**Before the
FEDERAL COMMUNICATIONS COMMISSION
Washington, D.C. 20554**

In the Matter of)
)
Applications for Public Safety Pool (Conventional) **File Nos. 0004270113**
Licenses in the 430-448 MHz Band for Mobile Use) ***et al.***
of ReconRobotics Video and Audio Surveillance)
Systems)

**REPLY TO OPPOSITION TO
PETITION FOR RECONSIDERATION**

Figure 2 -- This excerpt from the ReconRobotics supplemental report shows the measurement of “necessary bandwidth” of the Scout viewing a white raster screen.

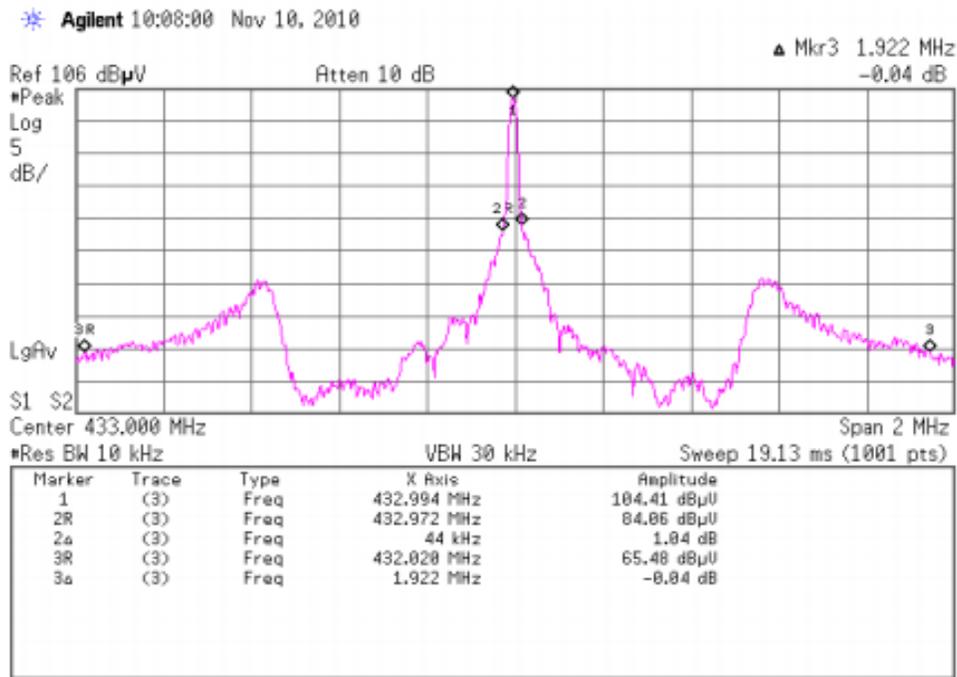
5. The 99% bandwidth of video modulation is essentially composed of lower frequency components, so in the case of high-speed video, a measurement of occupied bandwidth, even if correctly done, is not the same as necessary bandwidth. This point is clearly made in the rest of the spectral graphs that ReconRobotics showed in its supplementary report. The report shows that the spectral components vary significantly with the video pattern. Those additional spectral components, at levels lower than -20 dB below the video carrier, are very much necessary to convey the information that is in the pattern used for test equipment. Without those components, the pattern used to modulate
